Subject: Indian Point 3 Nuclear Power Plant
Docket No. 50-286
**Response to Request for Additional Information
Concerning Proposed Technical Specification Changes
For a 100% Helium Release from the Boron Coating of the Integral
Fuel Burnable Absorber Rods and a Reduction of Maximum
Permissible Reactor Coolant System Average Temperature**

**RESPONSE TO REQUEST FOR ADDITIONAL INFORMATION
REGARDING PROPOSED CHANGES TO TECHNICAL SPECIFICATIONS FOR A 100%
HELIUM RELEASE FROM THE BORON COATING OF THE INTEGRAL FUEL BURNABLE
ABSORBER RODS AND A REDUCTION OF MAXIMUM PERMISSIBLE REACTOR COOLANT
SYSTEM AVERAGE TEMPERATURE**

SECL-96-046
IFBA HELIUM RELEASE EVALUATION FOR CYCLE 9 RESTART

Figure 2.1-1

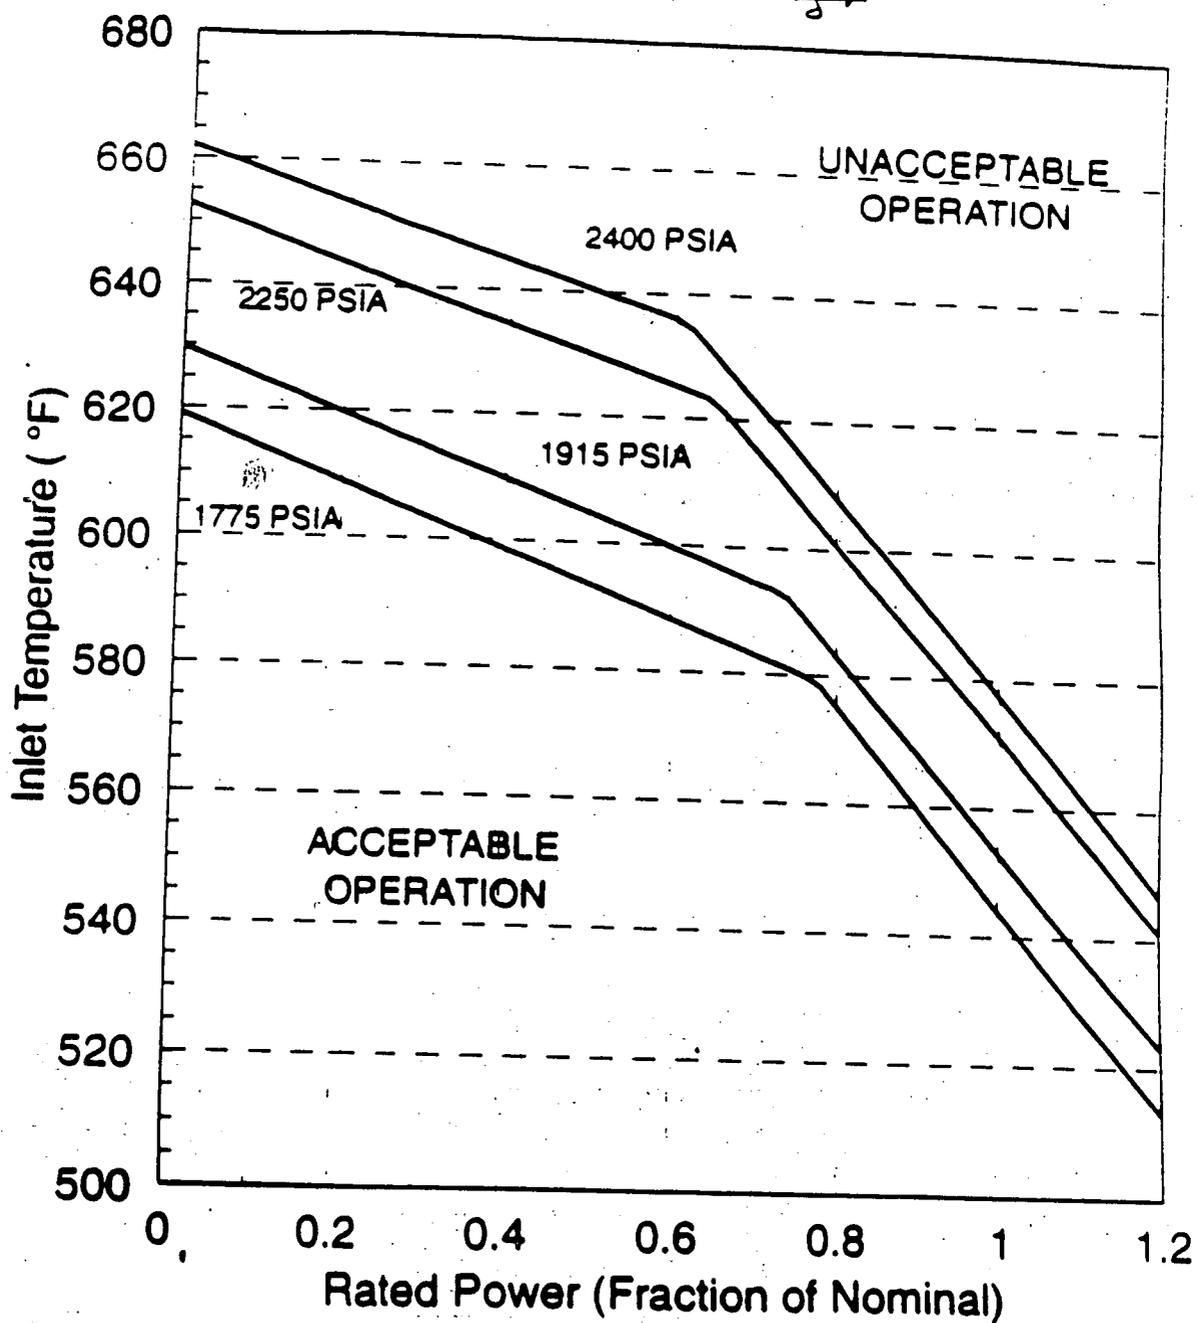
Based on a Reactor Coolant Flow of greater than or equal to 385400 gpm
